MODEL
2007 XK

NUMBER
XK501-004

TECHNICAL BULLETIN

Console Ashtray Lid Will Not Remain Open, is Slow or Noisy

Figure 1

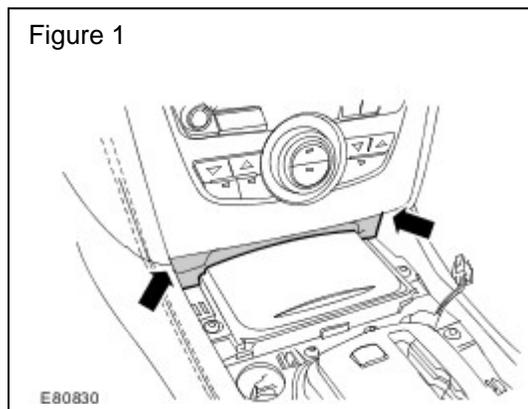
CAUTION: To avoid damage to the components, the hooked screwdriver, or suitable tool, must be carefully inserted as high up the ashtray cover panel as possible when releasing the clips to remove the ashtray cover panel. (Arrowed in Figure 1)

2. Using a thin hooked screwdriver, or suitable tool, release the two clips securing the ashtray cover panel. (Arrowed in Figure 1)
3. Remove the ashtray cover panel.
4. Check operation of ashtray lid.
5. If the ashtray lid operation 'noise' has disappeared or the 'slow' operation has been resolved, modify the ashtray cover panel as follows:
 - Select a suitable fine file.
 - Lightly file along the lower edge of ashtray cover panel, removing only enough material to allow smooth operation of the ashtray lid. (Figure 2)
6. Install the ashtray cover panel.
7. Verify that the lid operates properly and no noise is present.
8. Refer to GTR Workshop Manual, section: 501-12 operation 76.47.26 and install the floor console veneer panel.

Figure 3

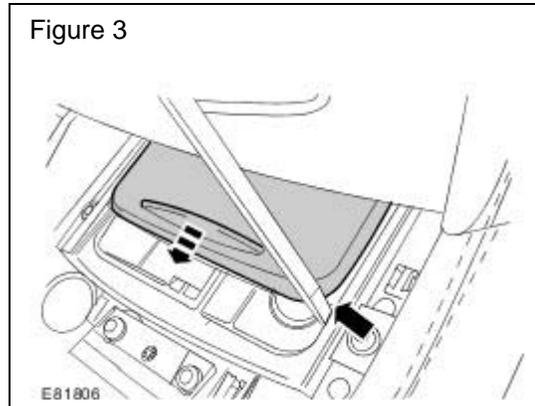
1. If the ashtray lid will not remain open, refer to GTR section 501-12 operation 76.47.26 and remove the floor console veneer panel.
2. Using a thin screwdriver, or suitable tool, hold the ashtray lid a quarter of the way open. (Solid arrow in Figure 3)

3. Pull the veneer towards the rear of the vehicle to release the four securing clips. (Dashed arrow in Figure 3)
4. Slide the ashtray lid veneer panel off to remove.

Figure 4

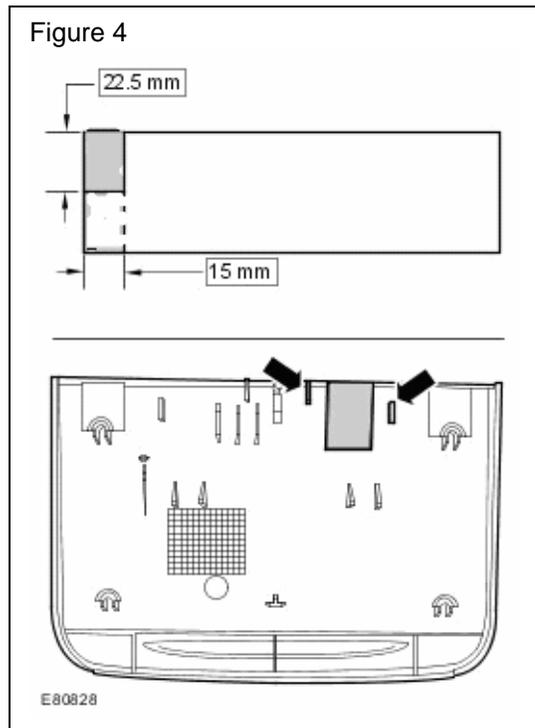
5. Check operation of ashtray lid.
6. If the ashtray lid latches, perform the following:
 - Cut a piece of foam pad to the dimensions 22.5 mm x 15 mm (0.9 in. x 0.6 in.) as illustrated. (Shaded in Figure 4)

- Apply the foam pad to the back of the ashtray lid veneer between the tabs as illustrated. (Arrowed in Figure 4)
 - Slide the ashtray lid veneer panel onto the ashtray lid to install.
